UNITED STATES PATENT AND TRADEMARK OFFICE

DETAILED ACTION

This is a first office action for serial number 09/818851, entitled Manufacture and use of Earthquake Resistant Construction Blocks, filed on March 28, 2001.

FIG. 3.

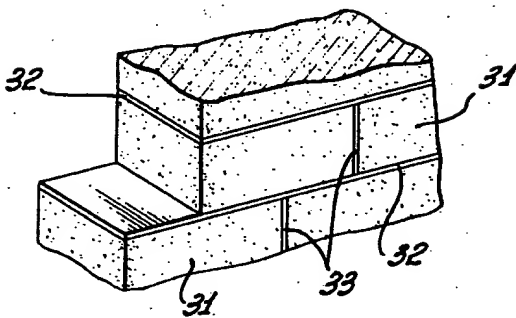
IGuastavino discloses the claimed invention a structure including a construction block (7) having an upper and lower surface and side surfaces (see attached figure 3); a plurality of construction blocks is places adjacent to one another (figure 3); the construction block is formed in the shape of a parallelepiped (figure 5), a plurality of the blocks (7) is placed side by side adjacent to one another in the shape of an arch (figure 3); and, the parallelepiped blocks placed in the form of an arch have their intrados ends abutting each other and their extrados ends spaced from each other (see attached figures 3 and 4), concrete is within the space between the blocks extrados ends (see attached figure 3); except for aggregate pieces within the block adjacent to the lower surface, the aggregate pieces being in direct contact with one another the aggregate pieces held in contact with each other by mortar, the block is in the shape of a tetrahendron, the aggregate material is coarse and fine, low quality, slag, crushed stone, concrete chips and Sirasu. Sandorff teaches that it is known in the art to provide aggregate pieces (35) within the block (30) adjacent to the lower surface (37), the aggregate pieces being in direct contact with one another (column 6, lines 35-37, by
